REV.	DATE	DCN #	DRAWING TREE #
A	23MAR05	E050063-00-K	E0500062-A-K

1. DO NOT SCALE FROM DRAWING 2. REMOVE ALL SHARP EDGES, R.02 MAX. 3. ALL MACHINING FLUIDS SHALL BE WATER SOLUBLE AND FREE OF SULFUR, CHLORINE AND SILICONE, SUCH AS CINCINNATI MILACRON'S CIMTECH 410 (STAINLESS STEEL) ④ SCRIBE, ENGRAVE OR MECHANICALLY STAMP DRAWING (NO INKS OR DYES) PART NUMBER, REVISION ON NOTED SURFACE OF PART FOLLOWED ON THE NEXT LINE WITH A THREE DIGIT SERIAL NUMBER. SERIAL NUMBERS START AT 001 FOR THE FIRST ARTICLE AND PROCEED CONSECUTIVELY. USE .12" HIGH CHARACTERS, UNLESS THE SIZE OF THE PART DICTATES SMALL CHARACTERS. A VIBRATORY TOOL MAY BE USED. EXAMPLE: D050035-A S/N 001				TOLERANCES: .XX ± 0.01 .XXX ± 0.005			
				ANGULAR ± 0.5 °		SUB-SYSTEM SUS	
				MATERIAL 303/304 SST		NEXT ASSY C-Ptype ETM TOP MASS	
				FINISH 32 μ inch		PART NAME T-PIECE ADDED MASS CYLINDER	
DRAWN M.Perreur-Lloyd		DATE 22SEP04		SIZE A		DWG. NO. D040486	
CHECKED C.Torrie		DATE 30MAR05		REV. A		SCALE: 1:1 PROJECTION:

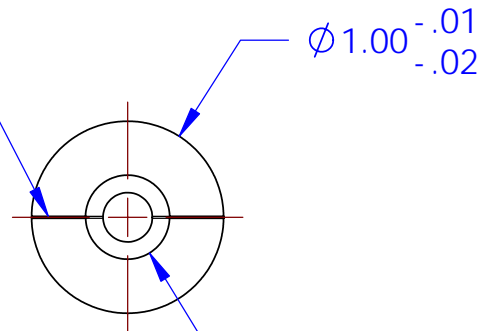
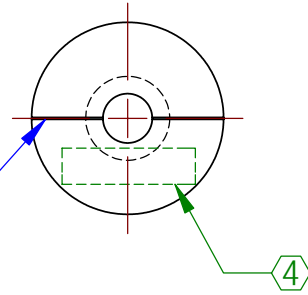
ADD VENT GROOVES
.02 WIDE BY .02 DEEP
ON BOTH END FACES
